Greater Dublin Drainage Project

Response to Submissions

Uisce Éireann

17 October 2024

Image 4: Street View of Portmarnock Public Park (Google Earth 2024) (accessed 19.07.2024)

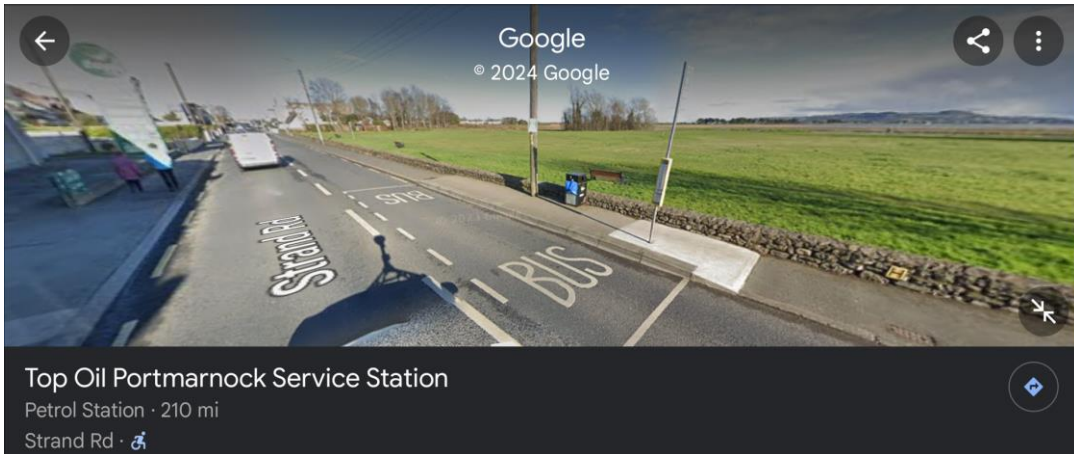
To further illustrate the point, the level of exposure to human activity that geese using Portmarnock Public Park are exposed to is evident in Image 4 below. Although not evident in the image, from personal observation at this location, Portmarnock Public Park is used by walkers (including with dogs), and has a footpath running across it, but nonetheless, Light-bellied Brent Geese were seen feeding within close proximity to busy road traffic and within 15m of walkers in the park.
